Project Name: Whitemarsh Collision Parking  
Expansion (Waiver Request)

Reference: Request for Waiver of Land Development  
Whitemarsh Collision  
4100 Butler Pike  
Whitemarsh Township, Montgomery County, Pennsylvania  
SLD #09-24

**RE: SLD #09-24: Whitemarsh Collision, Inc.; 4100 Butler Pike  
Land Development Waiver Request for New Parking Lot  
Zoning Ordinance Compliance Review Letter**

GP#2024-26 Paul & Mary Lou Bartle-- Whitemarsh Collision (4100 Butler Pike)

SHEET NO.  
**SP-1**  
DATE: 12/20/24

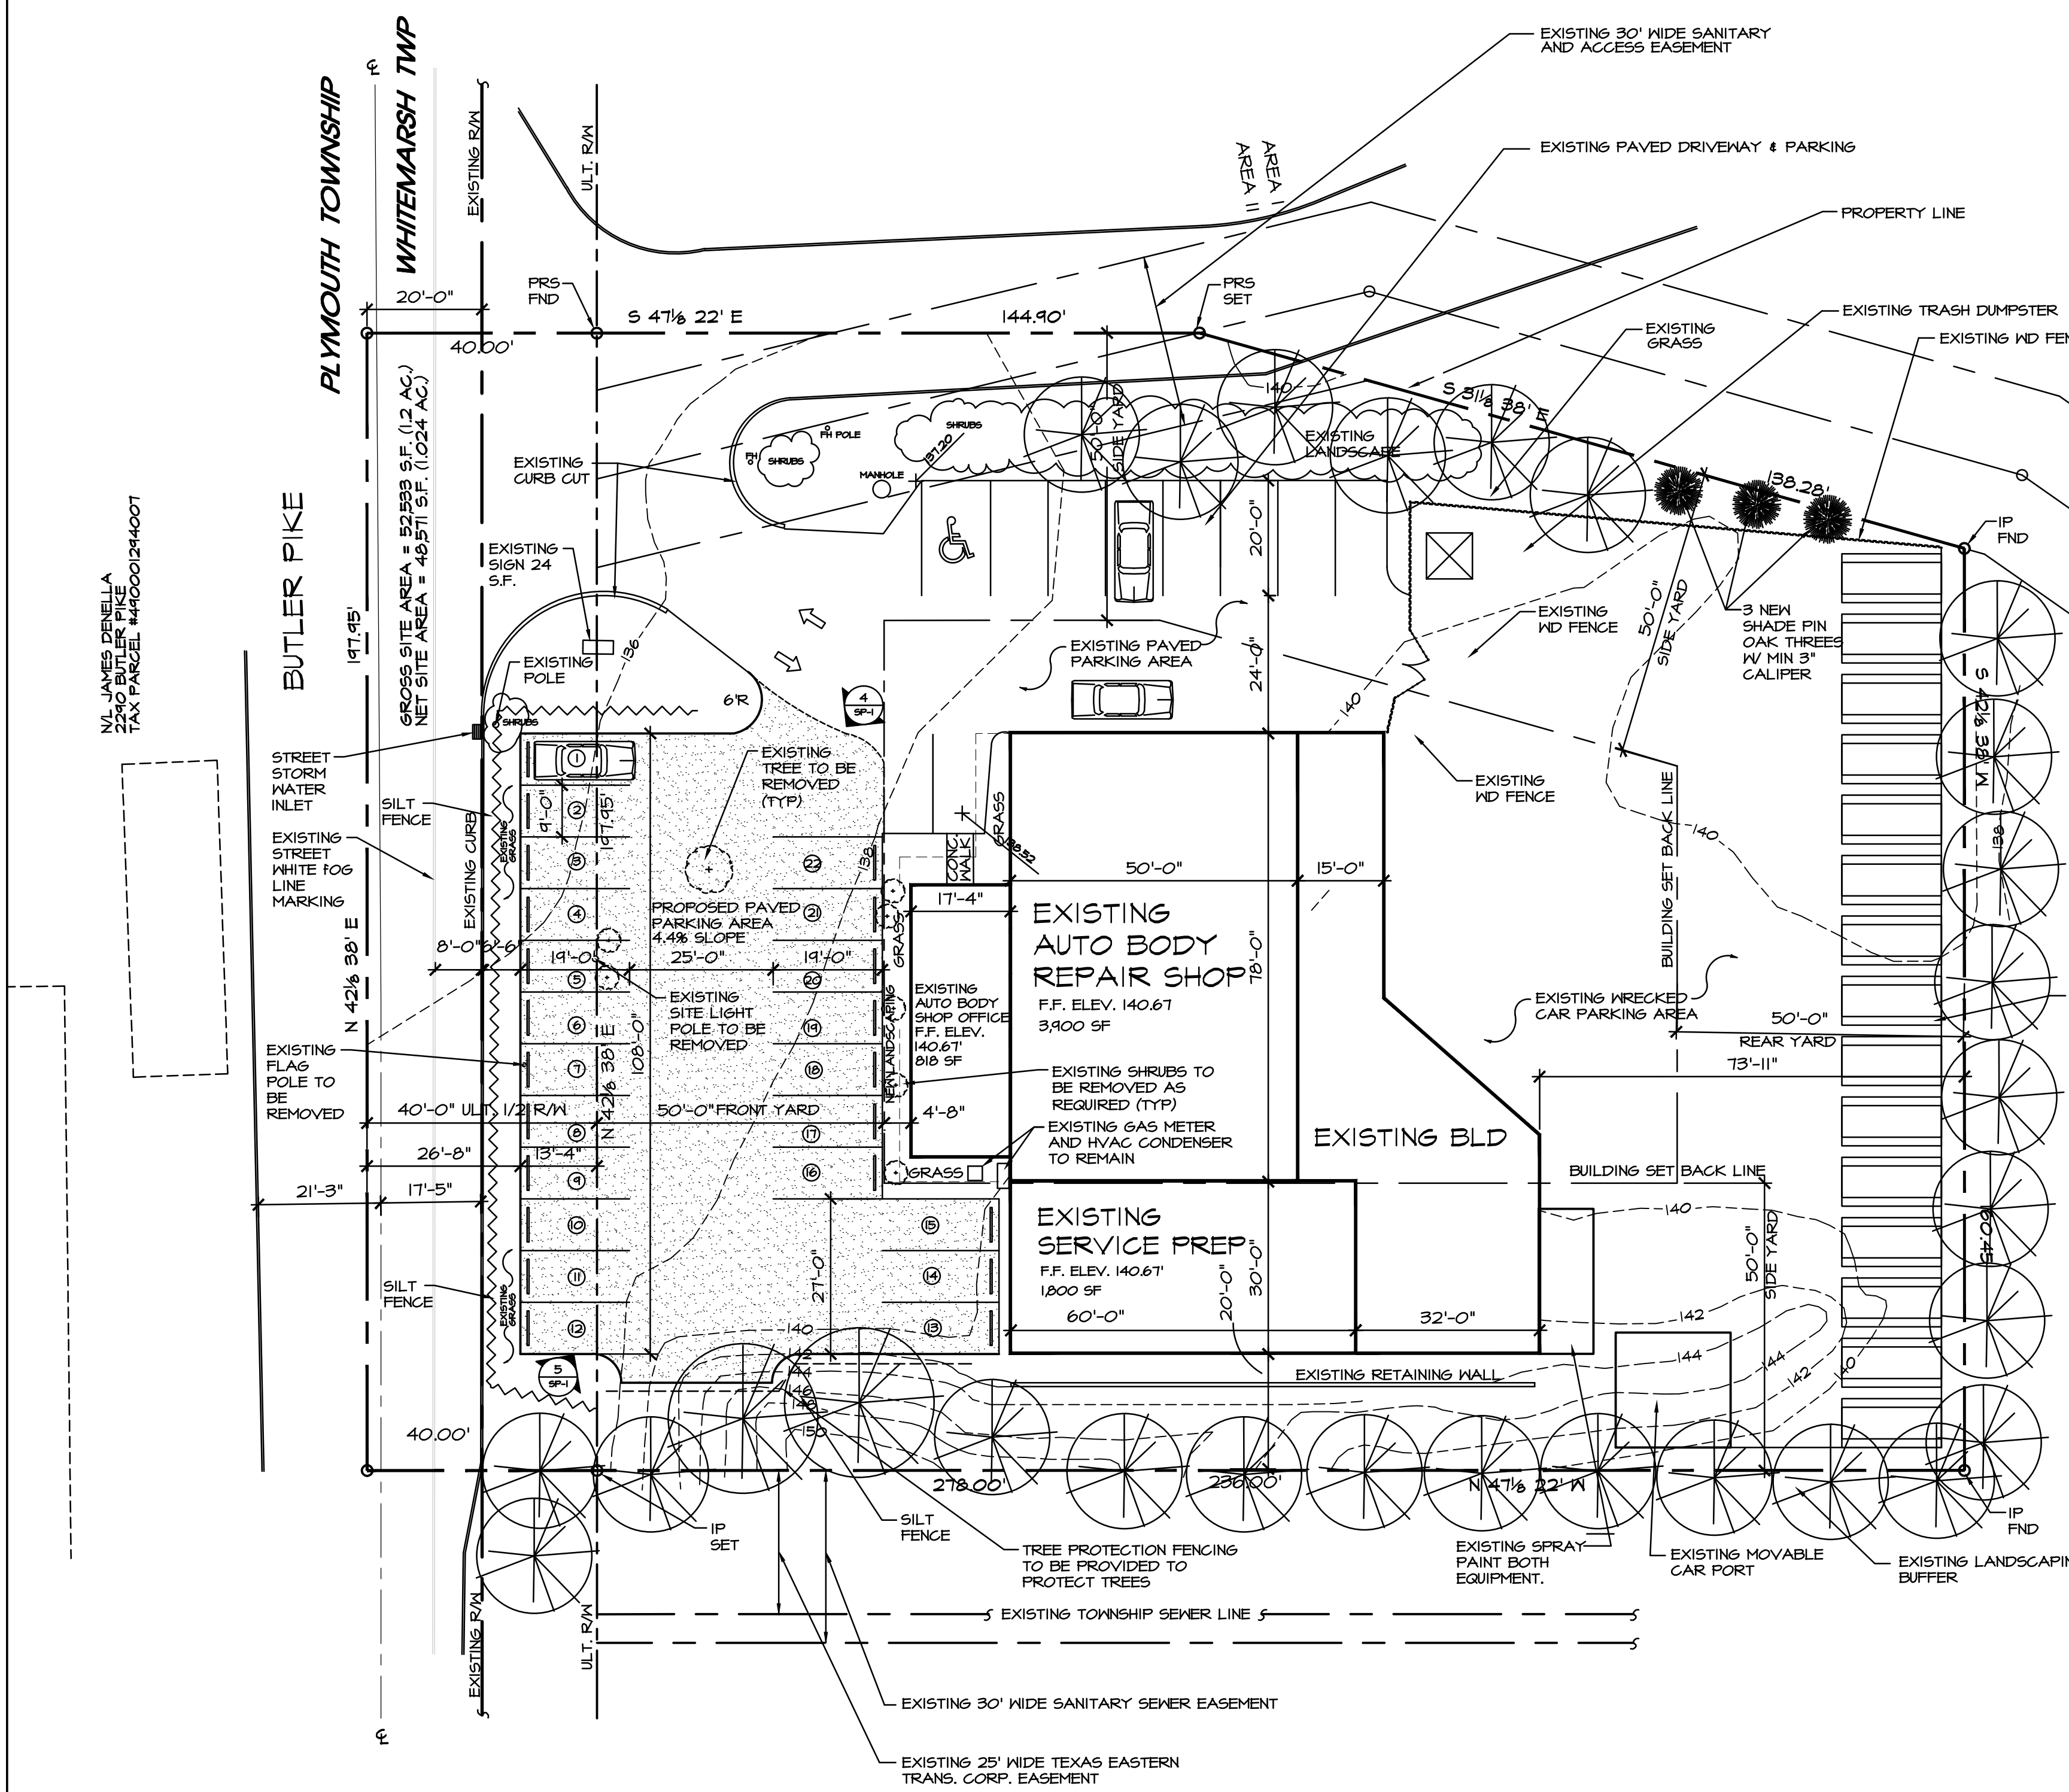
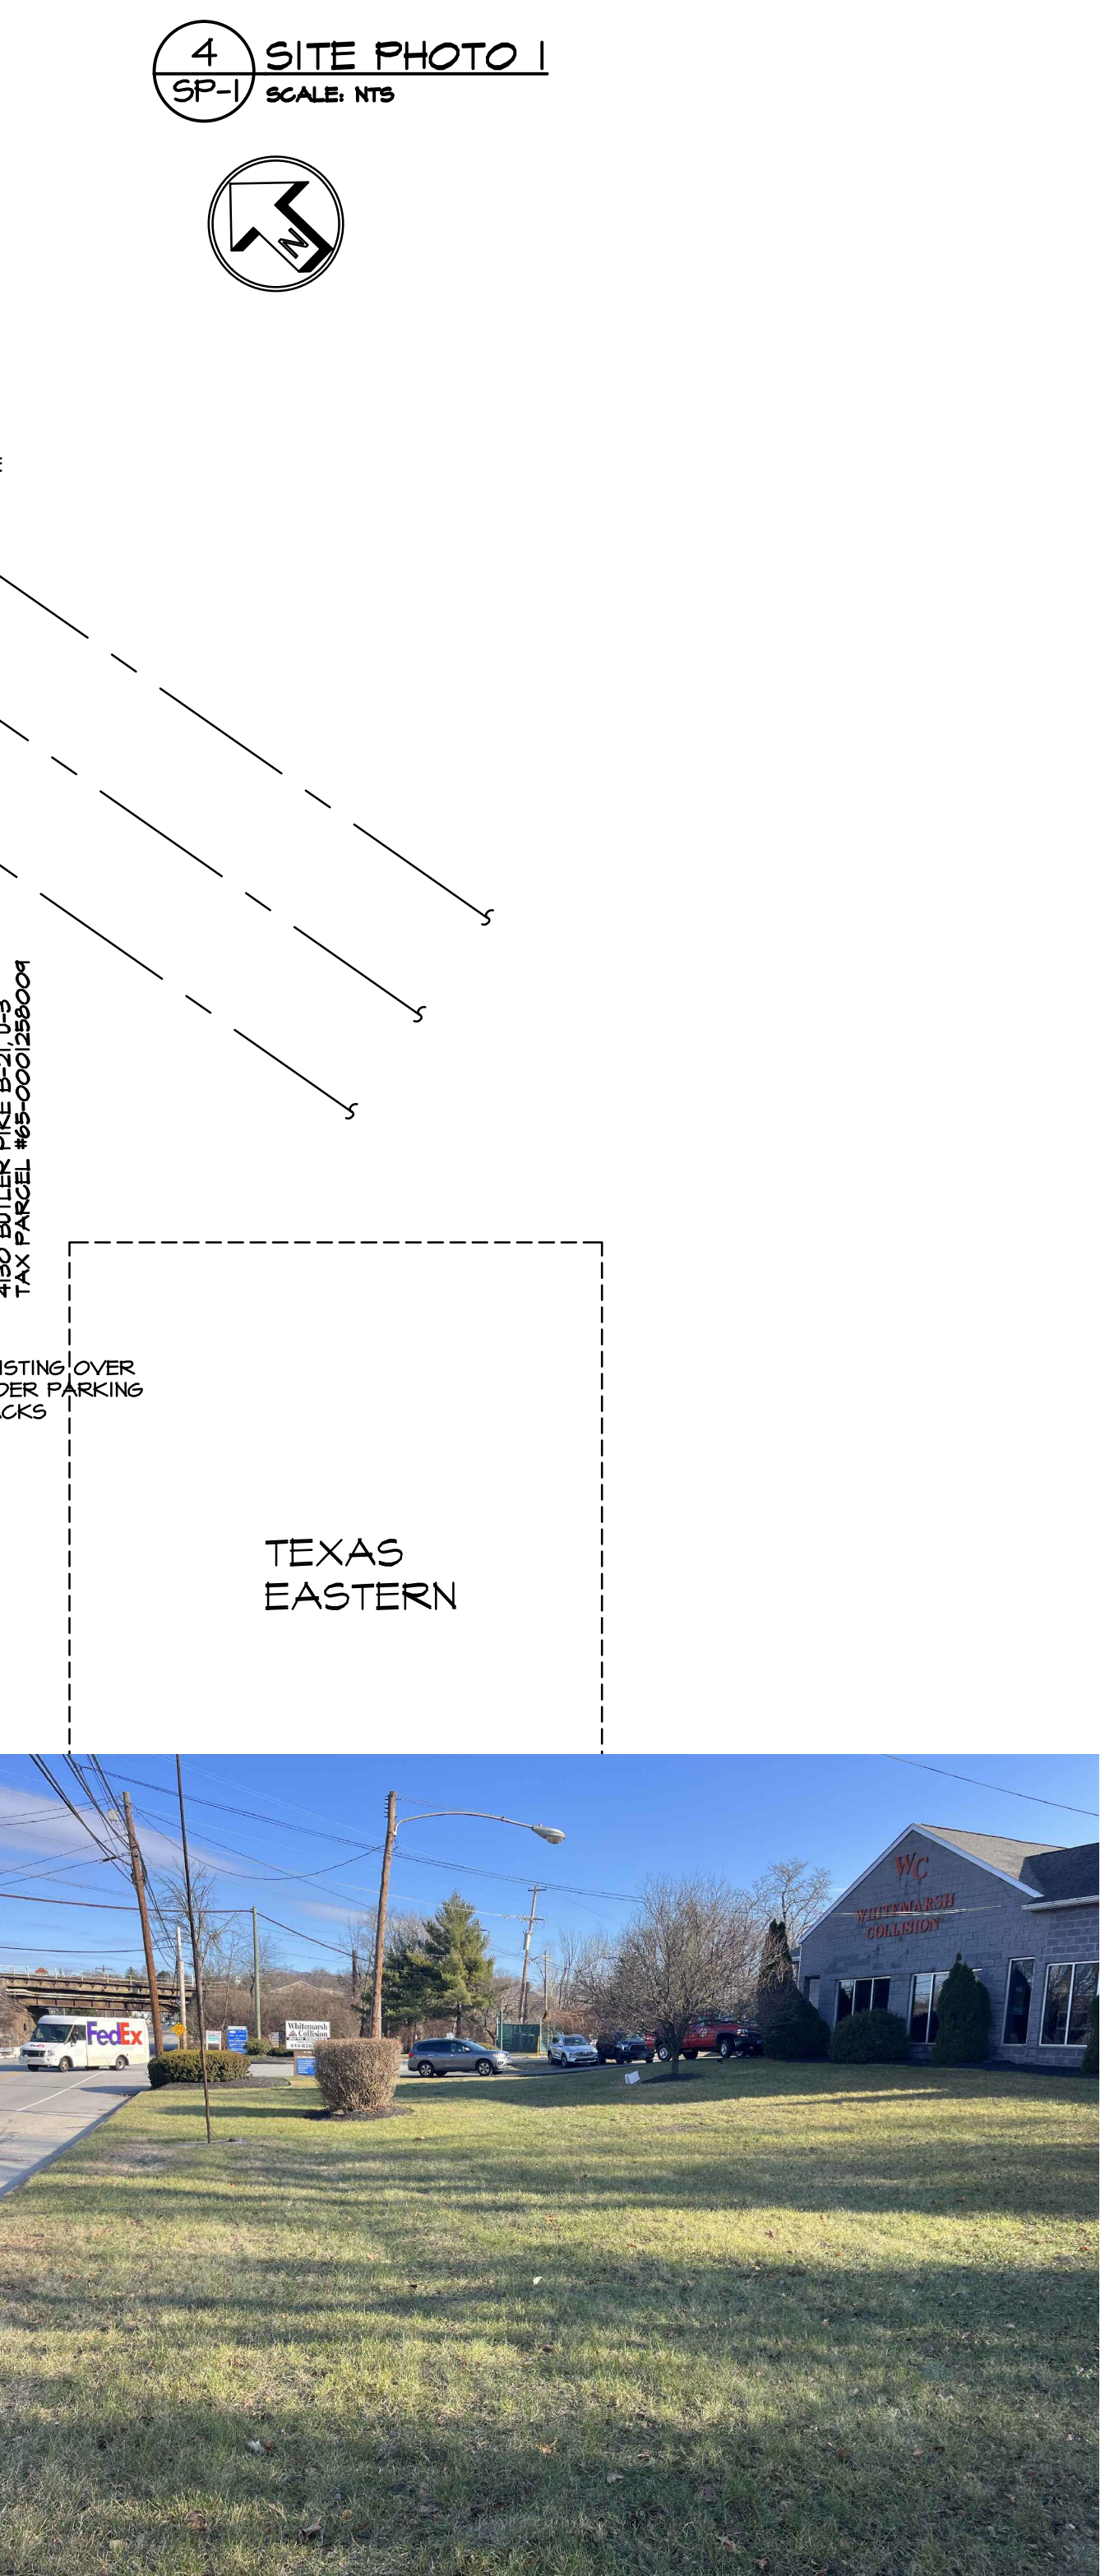
<u>Section</u>	<u>Issue/Comment</u>
8. §116-22.	A note must be added to the plan that states that the permanent removal of topsoil from land within the Township is prohibited.

9. §116-137.B.(1)	The building coverage calculations on the plan must be clarified. The 'Legend, Building Coverage Work Sheet' shows a building coverage of 17.5% based upon 9,184 sf of building area based on a lot area of 52,533 sf. The 'Zoning Data' chart shows a building coverage of 18.3% based on 9,623 sf of building area, also based on a lot area of 52,533 sf. The discrepancy between these building areas must be corrected. In addition, building area is based on the lot area outside of the legal right-of-way which appears to be 48,571 sf. The applicant must also determine if any required corrections to the building area has an impact on the impervious coverage requested as part of the pending Zoning Hearing Board application; impervious coverage is also based on the lot area outside of the legal right-of-way.

THE PERMANENT REMOVAL OF TOPSOIL FROM THE LAND WITHIN TOWNSHIP IS PROHIBITED.

WE PROPOSE TO DISTURBING 10-15 CY FOR THE NEW PARKING AREA AND NO SOIL WILL BE REMOVED FROM THE SITE.
